> Contract 8078, I-5, Columbia River Bridge Temporary Pile Test Program WA 0.3 to OR MP 308.0 State Project Serial Letter No. 18

RE: Change Order No. 2 – UHMW Rollers Credit

CHANGE ORDER NO: 2 UHMW ROLLERS - CREDIT

3 3 DETAIL ND2 ND3 TYPICAL ARM GUIDE Contract 8078
Change Order No. 2
Sheet 4 of 4

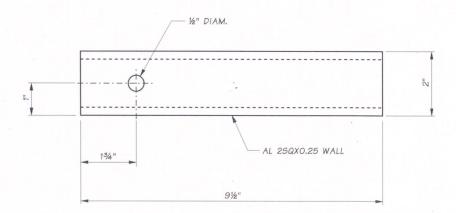
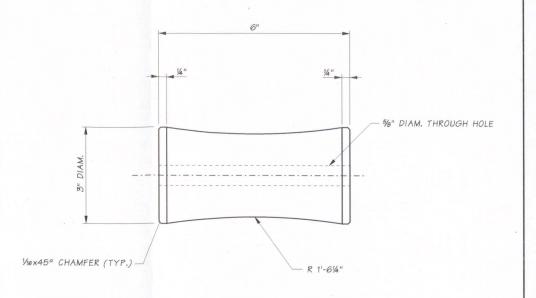
This change order allows the Contractor to substitute Ultra High Molecular Weight (UHNW) Polyethylene in lieu of the contract specified AASHTO Grade 60 Neoprene for rollers as shown on sheet 4 of 4 of this change order.

MATERIAL: ULTRA HIGH MOLECULAR WEIGHT POLYETHYLENE
